BEFORE THE UNITED STATES
NUCLEAR REGULATORY COMMISSION

IN THE MATTER OF)
) Docket No. 72-1050
HOLTEC INTERNATIONAL)
) DECLARATION OF GEORGE RICE
(Consolidated Interim Storage)
Facility Project))

Comments on Proposed Holtec Facility

George Rice
September 6, 2018

Figure 1
Schematic Cross-section of Holtec Site

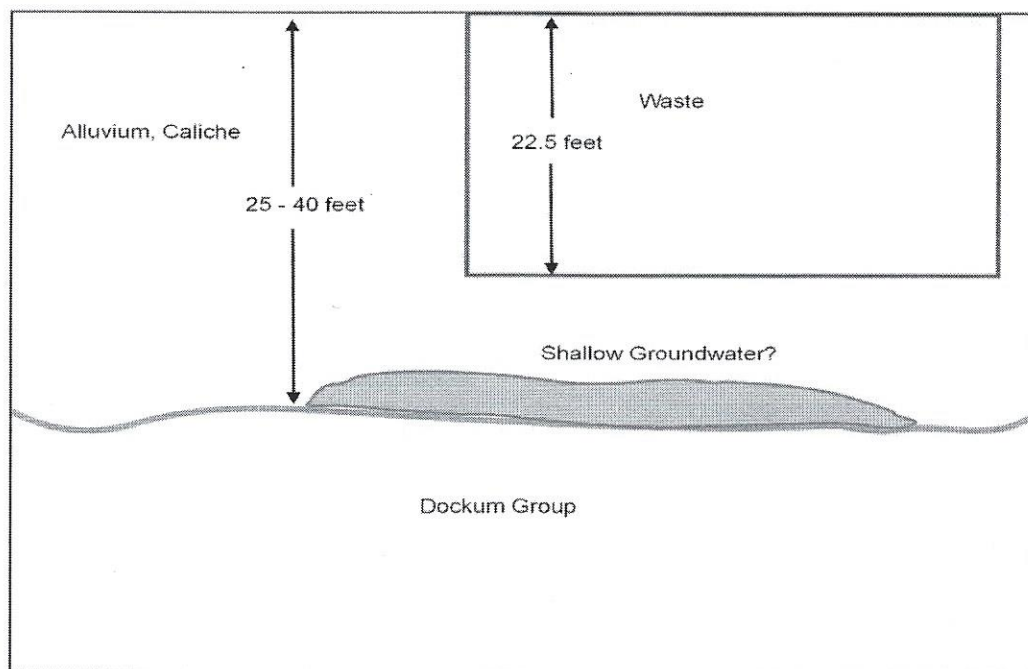
Comment 1: Failure to determine whether shallow groundwater exists at the site

If contaminants leak from the facility, they could be transported by shallow groundwater underlying the site. Shallow groundwater is groundwater that may exist in the alluvium, at its interface with the underlying Dockum (figure 1).

The applicant claims there is probably no shallow groundwater at the site.¹⁰ However, the applicant has not done the field investigations necessary to determine whether shallow groundwater exists.

The applicant should be required to perform the work necessary to determine:

- whether shallow groundwater exists at the site, and if it exists,
- the direction groundwater flow,
- the rate of groundwater flow,
- the rate at which contaminants could be transported by the groundwater, and
- the likely fate of the contaminants.

The question of whether shallow groundwater exists could be answered by installing a network of monitor wells at the site. These wells should be completed at the alluvium/Dockum interface.
